Cleveland City Planning Commission

October 2, 2026

Agenda: October 2, 2026

PRJ26-XXX – Gateway 55

EXTERIOR ELEVATIONS

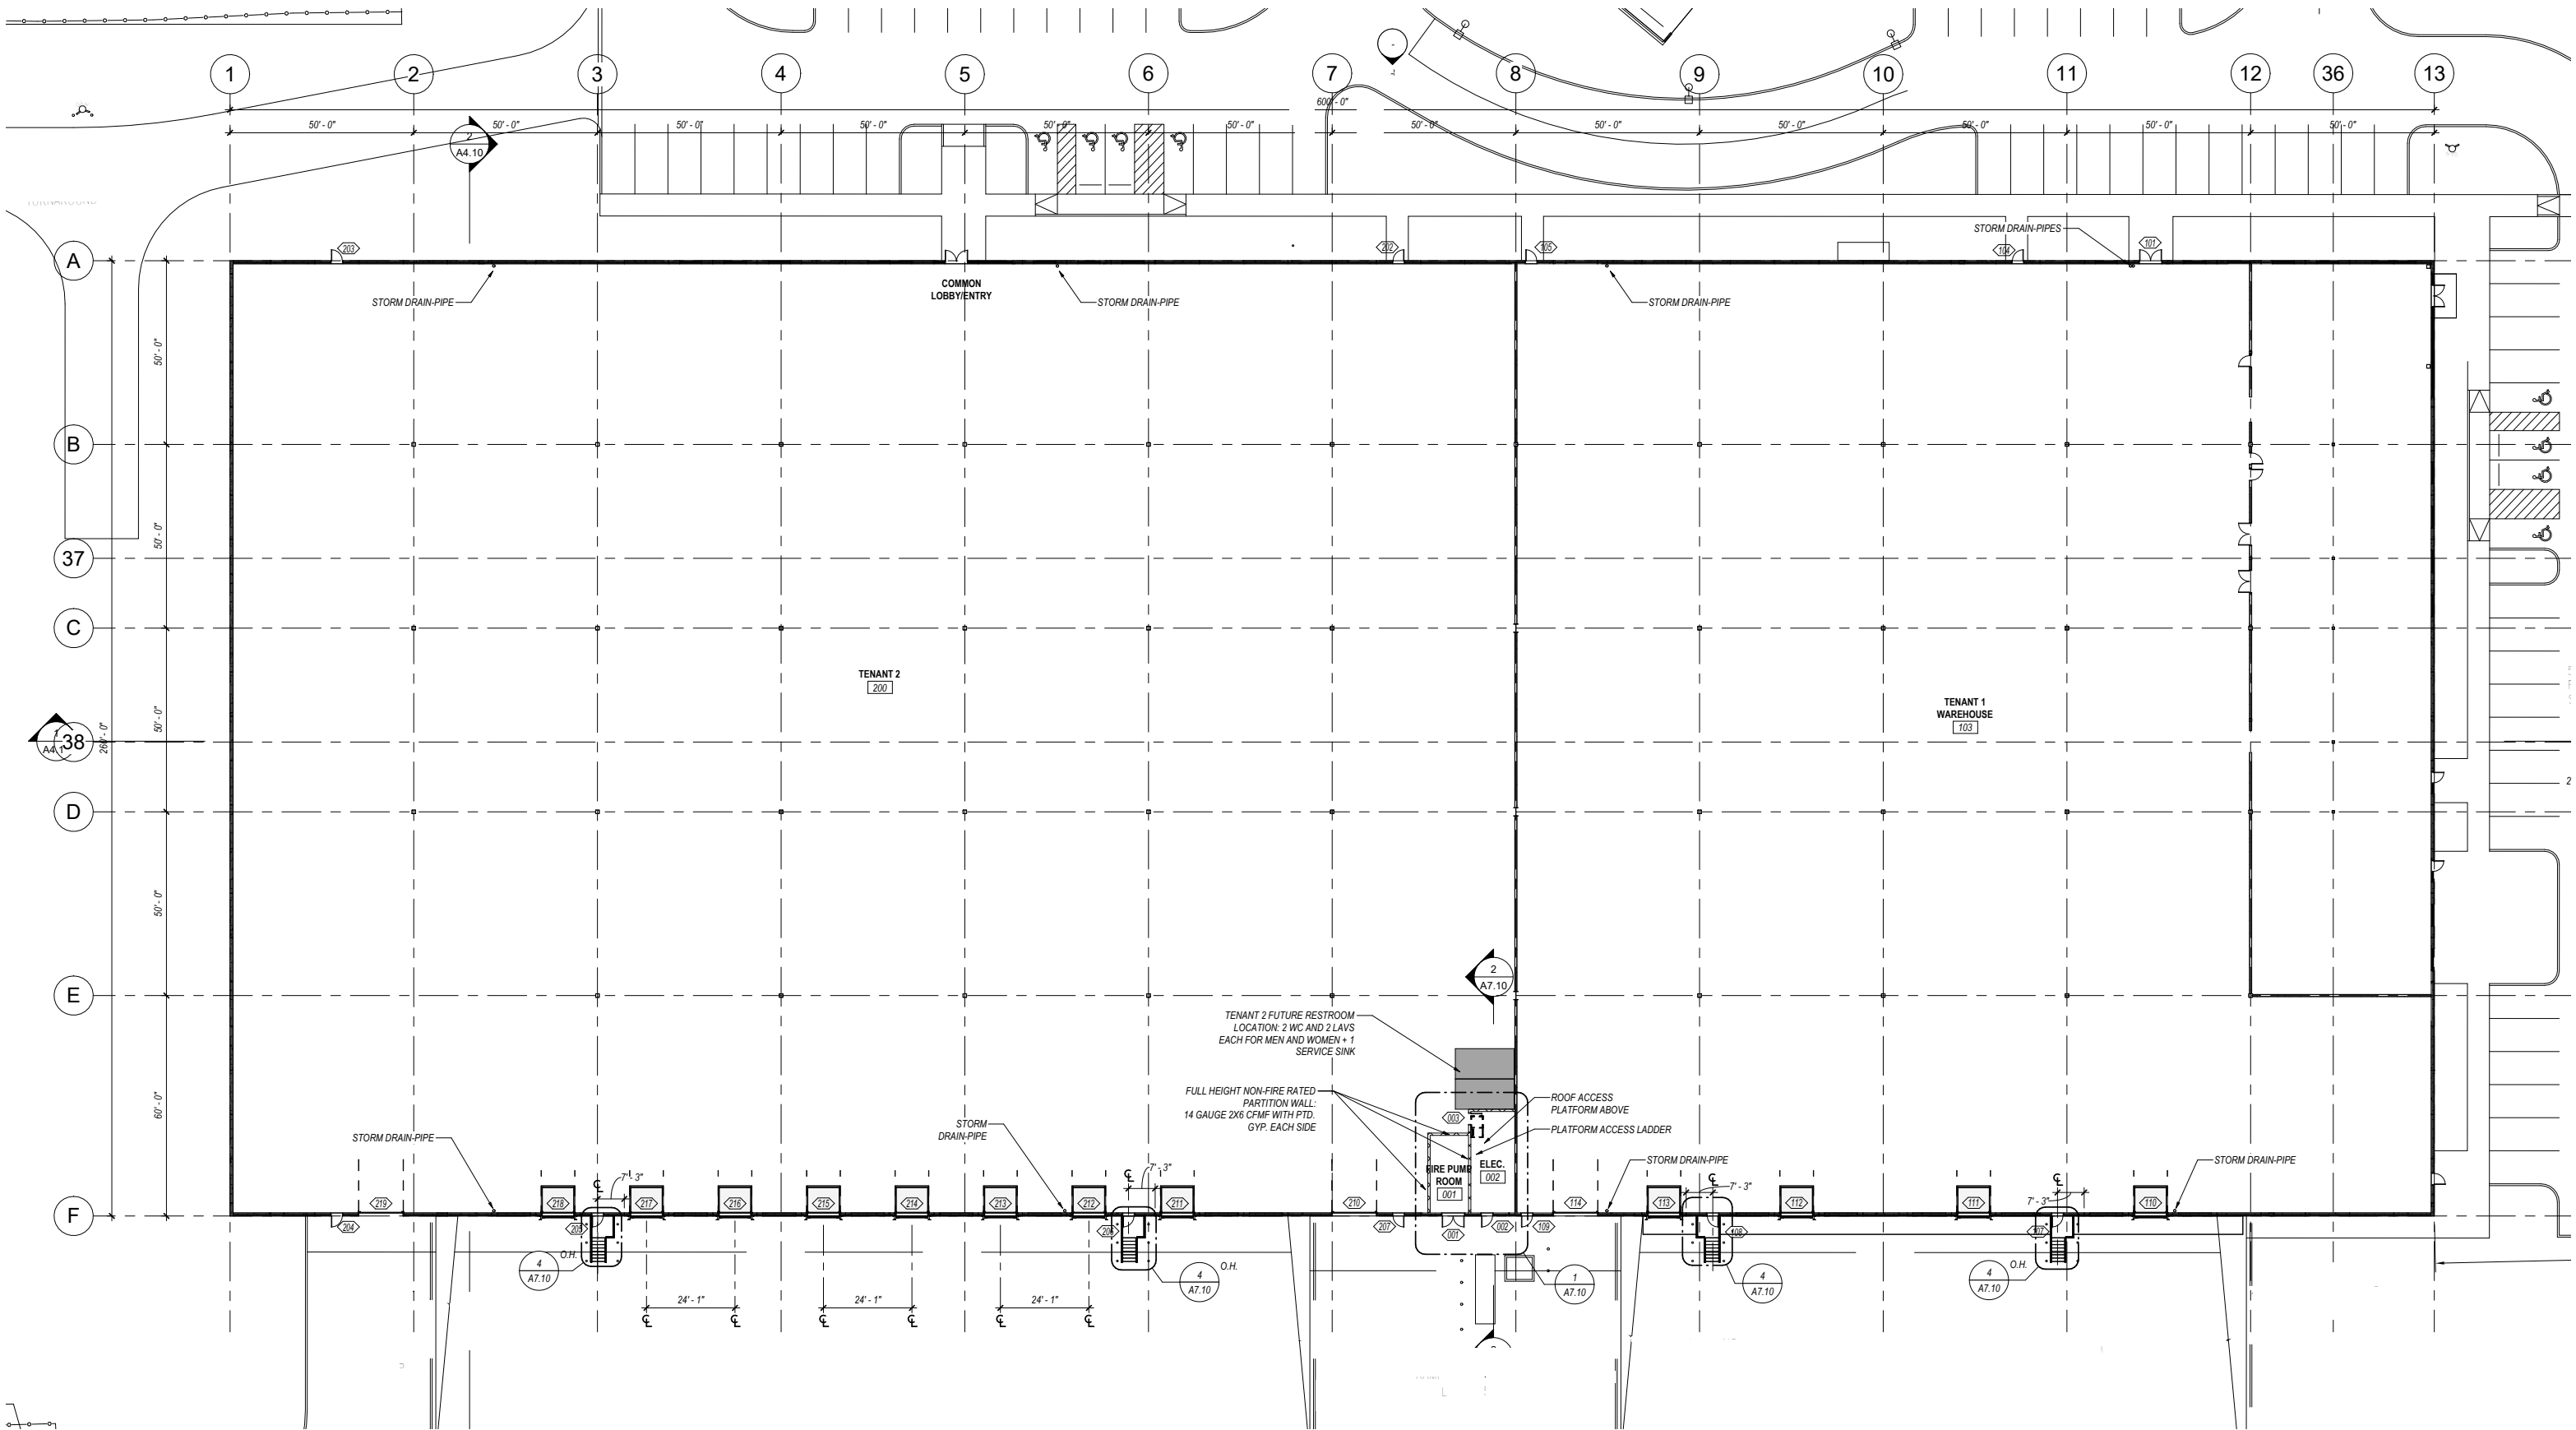
SEDRAC recommended schematic approval on 9/22/26 with the conditions to further study E. 55th façade, and include lighting & landscaping
